Re: Initial Submission Review: Living Water Car Wash at Smoky Hill Crossing - Conditional Use and Site Plan
Application Number: DA-2184-07
Case Numbers: 2020-6040-00; 2020-6040-01

Initial Submission Review

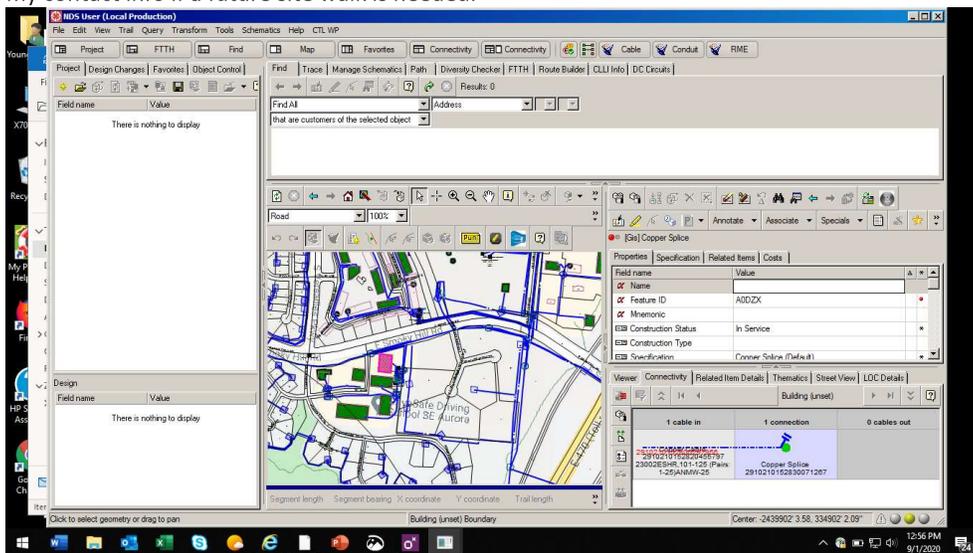
Here is a screen shot of our facility mapping system in that area. Please call out locates and protect our facilities in place when doing any construction, digging, etc. Feel free to pass along my contact info if a future site walk is needed.
